V8 XJ Series/XK

414-06

TECHNICAL BULLETIN

Intermittently Discharged Battery – Diagnostic Procedure

Diagnostic Routine

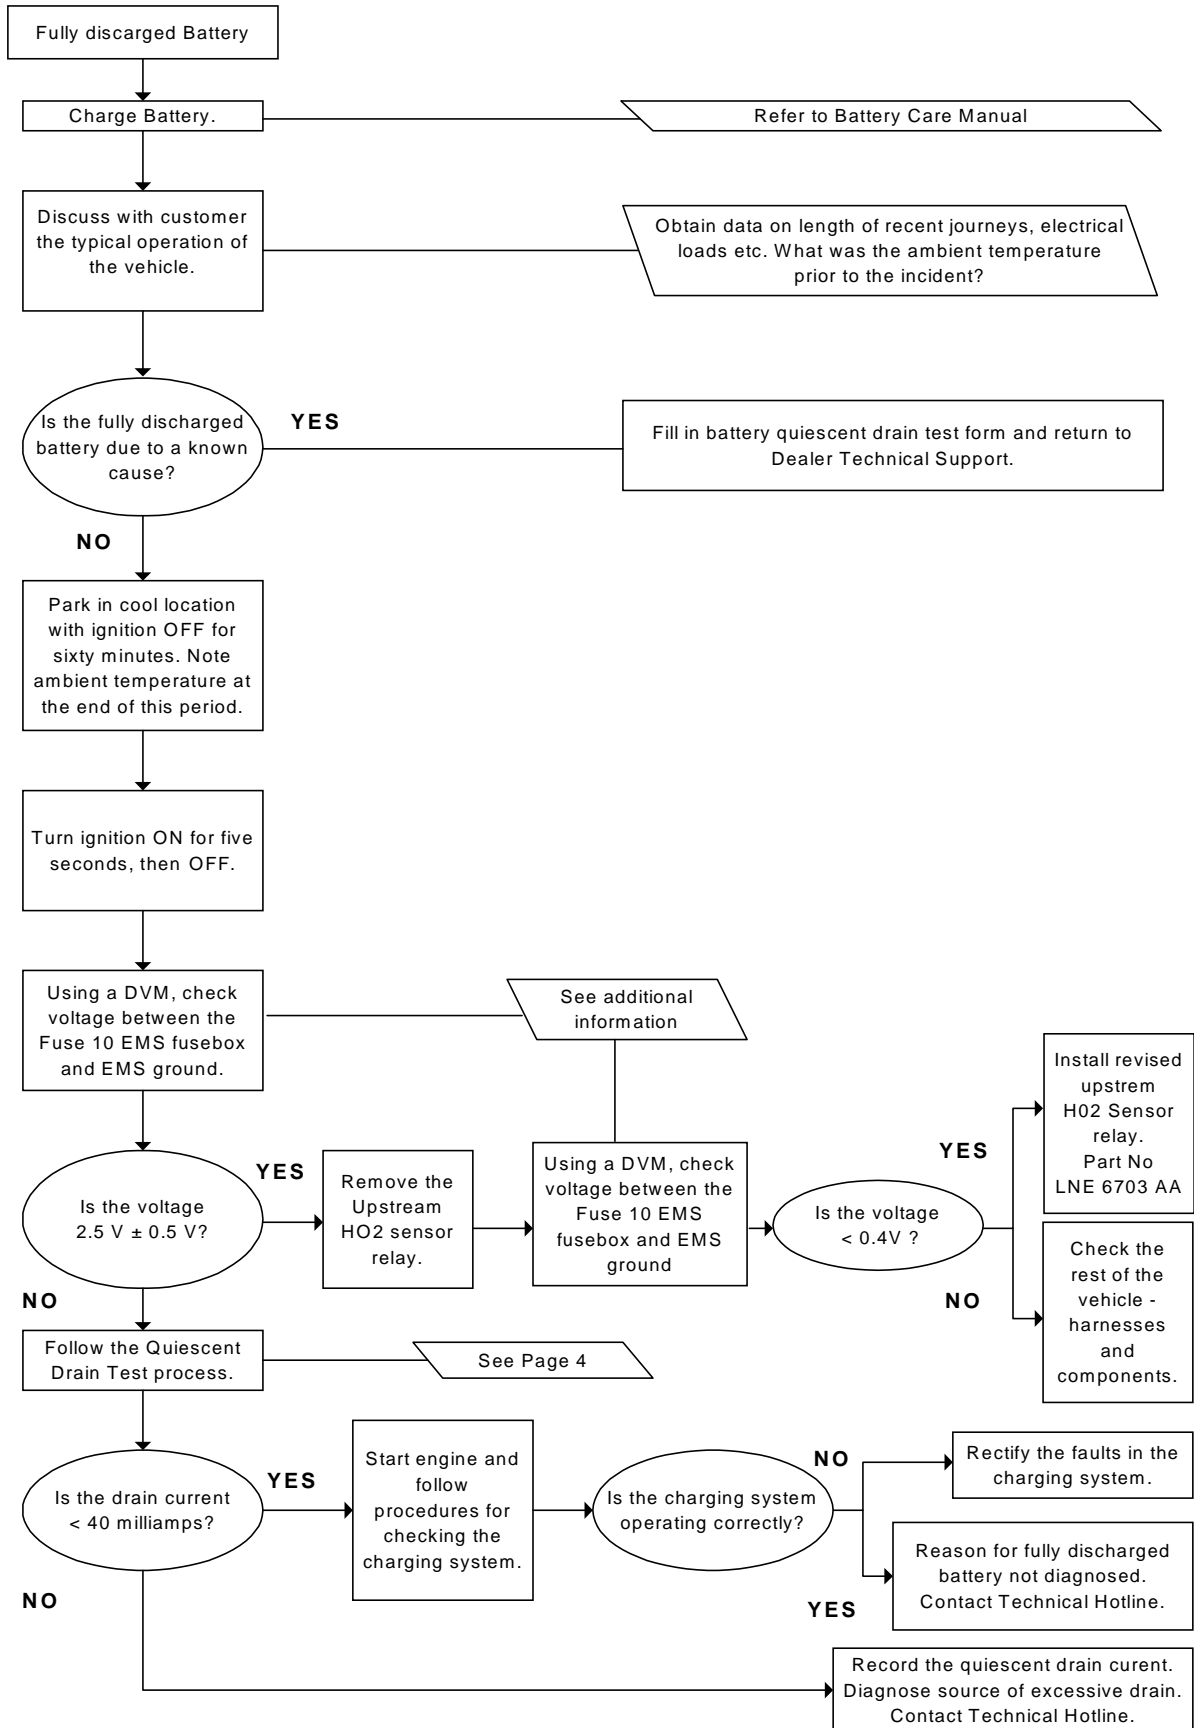
Refer to page 3 for Diagnostic Routine.

The Diagnostic Routine refers to the following notes:

Note No.	Models	Instructions	Comment
1	All	Connect Digital Volt Ohmmeter (DVOM) positive lead to center of Fuse 10.	
	XK8/XKR	Connect DVOM negative lead to ground at EM1 stud on right side false bulkhead or EM2 or LF3 stud on left side false bulkhead.	If relay is de-energized, indicated voltage should be less than 0.4 volts.
	X8 XJ Series	Connect DVOM negative lead to ground at EM16, 17 or 18 stud in center of bulkhead.	
2	All	DVOM Positive to center of Fuse 10.	
	XK8/XKR	Connect DVOM negative lead to ground at EM1 stud on right side false bulkhead or EM2 or LF3 stud on left side false bulkhead.	If voltage is 2.5 volts or more, it is likely that the Upstream HO2 Sensor relay failed to drop out, or remains energized.
	X8 XJ Series	Connect DVOM negative lead to ground at EM16, 17 or 18 stud in center of bulkhead.
